# AIA® Document G710™ – 2017

## *Architect's Supplemental Instructions*

**PROJECT:** *(name and address)*
17-13 OSU College of Med. at Hastings
Tahlequah, OK

**ASI INFORMATION:**
ASI Number: 02
Date: 11-18-19

**1 ENLARGED POWER PLAN LEVEL 01 SECTOR 01**
1/4" = 1'-0"

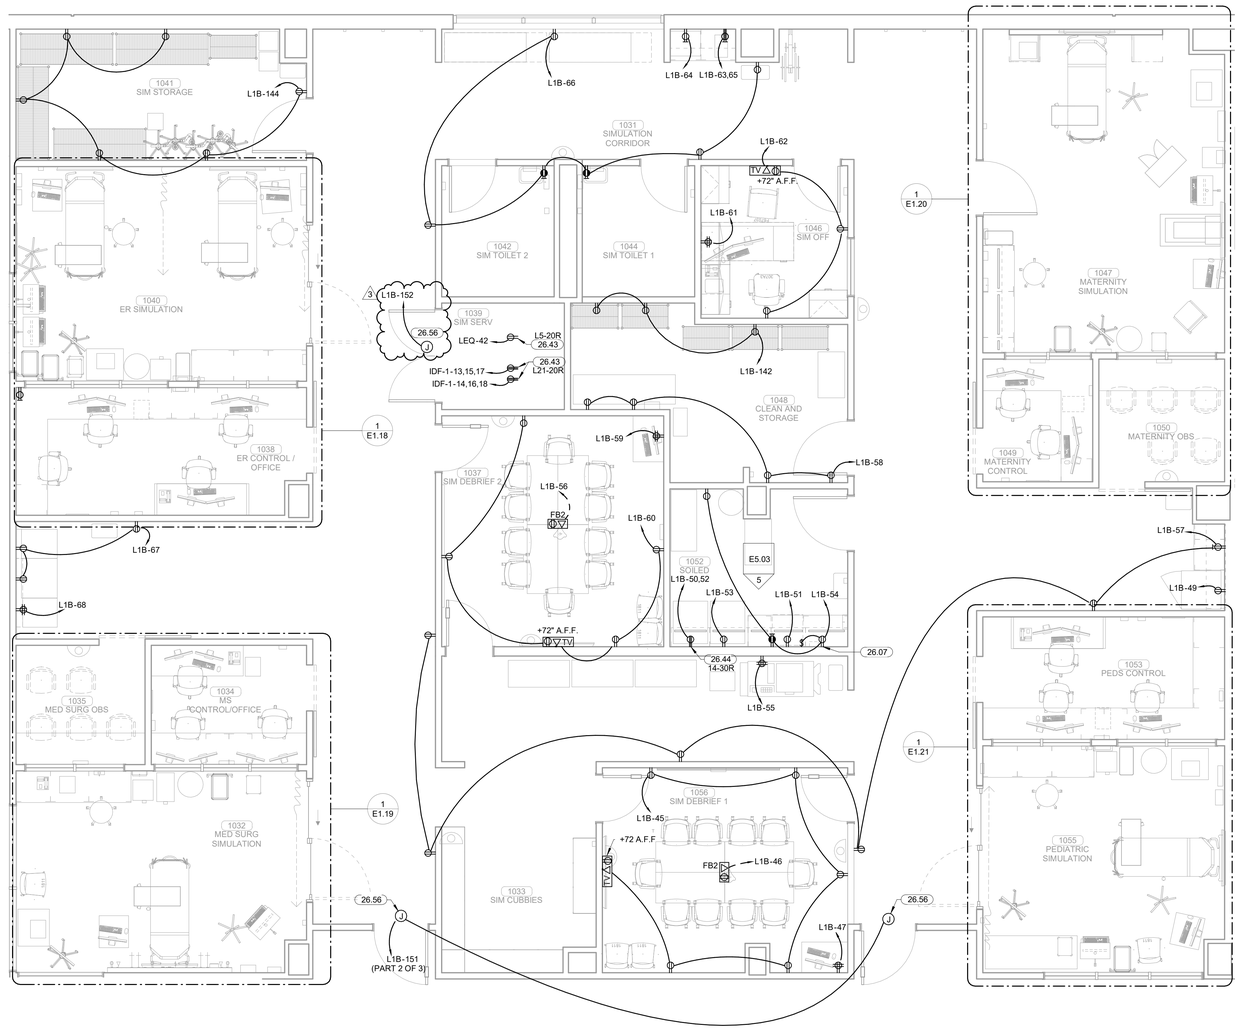
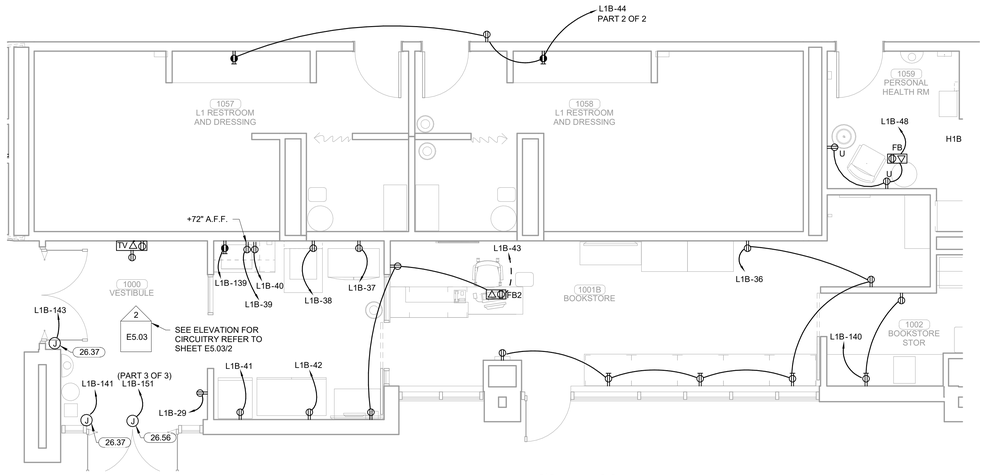
1. E1.04
    a. Added electrical circuit L1B-152 for access control on door 1039.
2. E1.05
    a. Added junction box and circuit L1A- 102 for Motorized Shades in LH-1.
3. E1.08
    a. Added junction box and circuit L2B-162 for Motorized Shades in Clinical Skills.
4. E1.15
    a. Added electrical circuit and hub location for access control on door 3000.
5. E1.37
    a. Revised low voltage schedule to include part numbers for WAP's, Cameras, and Card Readers.
6. E1.38
    a. Added card reader location for door 1039.
7. E1.43
    a. Added card reader location for door 3000.
8. E2.01
    a. Revised lighting fixture schedule to accommodate changes made in lighting submittal.
